Pilot Region-Based Optimization Program for Fund-Lead Sites in EPA Region 3

Site Optimization Tracker: Greenwood Chemical Site Newtown, Virginia

SUMMARY OF FOLLOW-UP #2

Site or System Name	Greenwood Chemical Site	
Date of This Follow-Up Summary	December 30, 2005	
Date of Follow-Up Meeting or Call (Indicate if Meeting or Call)	October 18, 2005 – Meeting

FIGURE 1-2. EXTENT OF VOC CONTAMINATION.

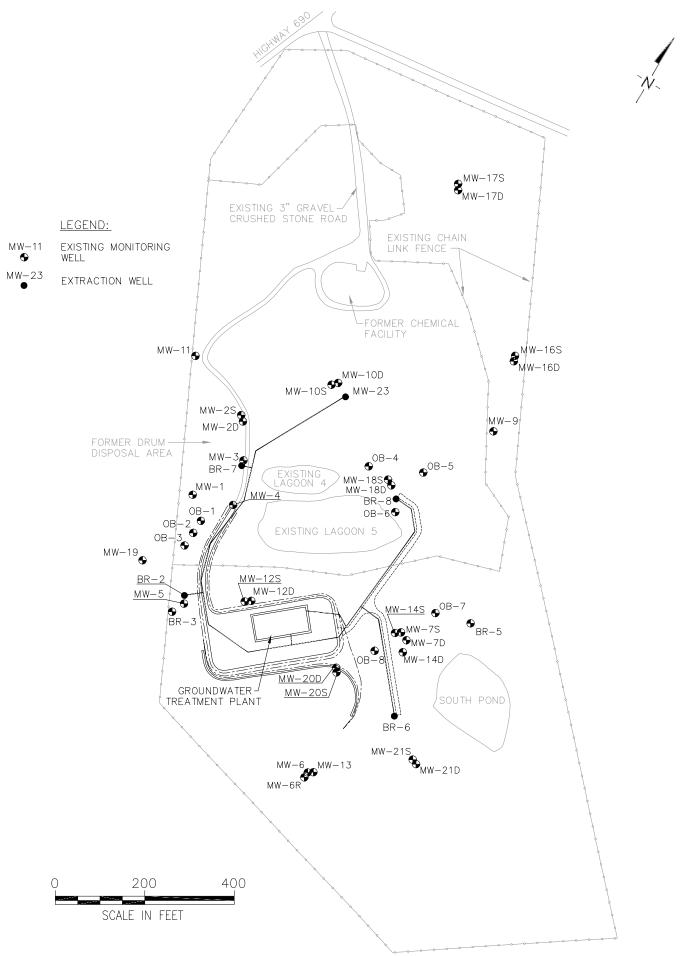
The contaminants of concern at the site are primarily VOCs, SVOCs, and metals. The VOC ground water data from September 2002 through June 2003 are shown in Tables 1-1 and 1-2 and VOCs are depicted on Figure 1-2. SVOCs, inorganic compounds, and tentatively identified compounds are not shown. Ground water quality data are not routinely tabulated as part of the site activities. Tables 1-1 and 1-2 were compiled by the optimization support team to provide the basis for analysis in this report. These data have been reviewed and are of sufficient quality for use in this report, but the optimization support team recommends that these data be thoroughly reviewed using a more rigorous QA/QC protocol.

At this site, the plume has not been fully delineated and a target capture zone has not been established. As indicated in Figure 1-2, contamination is present above site-specific standards (and above MCLs) at MW-21S and MW-21D. Contamination (albeit at low concentrations) is also present in BR-2, which is an extraction well that marks the furthest downgradient sampling point (in recent sampling events) on the western side of the property. Many of the deep wells at the site also have contamination with no deeper wells to provide delineation. MW-7D and MW-21D are examples of such wells. The concentrations at MW-7D and MW-21D are higher than at MW-7S and MW-21S (respectively), and it is possible that concentrations below MW-7D and MW-21D might actually increase with depth. The MW-14 cluster, which is adjacent to the MW-7 cluster, has bedrock wells which are deeper than those of the MW-7 cluster, but the sampling data from the past year (4 quarters) indicate that the MW-14 cluster has not been sampled.
